Appl. No. 10/687,947
Amdt. Dated December 9, 2005
Reply to Office Action of August 10, 2005

REMARKS/ARGUMENTS

FIG. 4(a) **PRIOR ART**

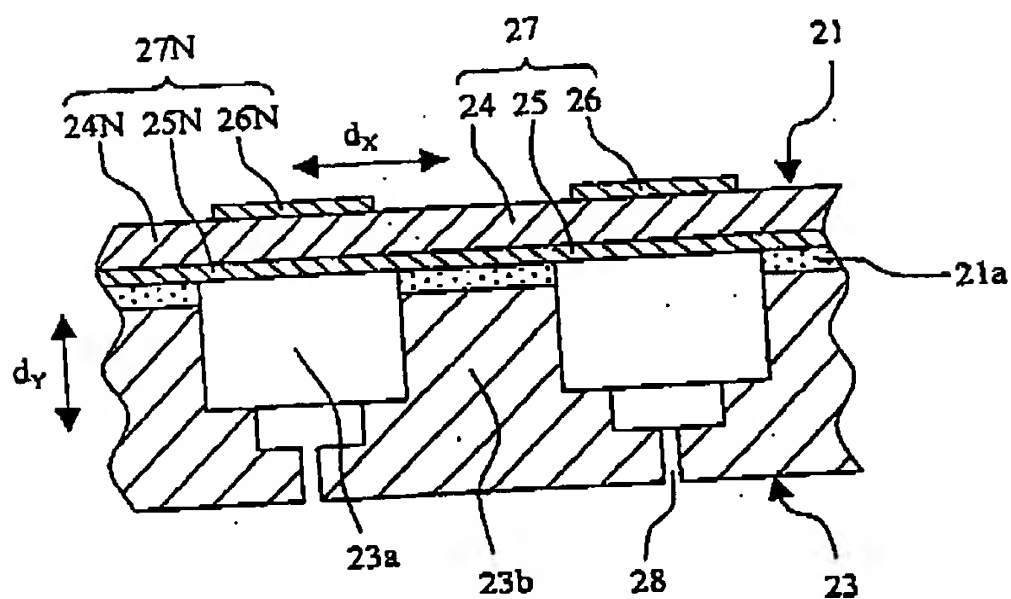
Figures 4(a) and 4(b) stand objected to because the office contends that Figs. 4(a) and 4(b) should be designated with a legend such as --Prior Art--. In response, Applicant has added the legend --Prior Art-- to Fig. 4(a) and Fig. (4(b). Withdrawal of the objection is respectfully requested.

The attached sheet of drawings includes changes to Fig. 4(a) and 4(b). This sheet, which includes only Figs. 4(a) and 4(b), replaces the original sheet. In Figure 4(a) and 4(b), a legend --Prior Art-- has been added.
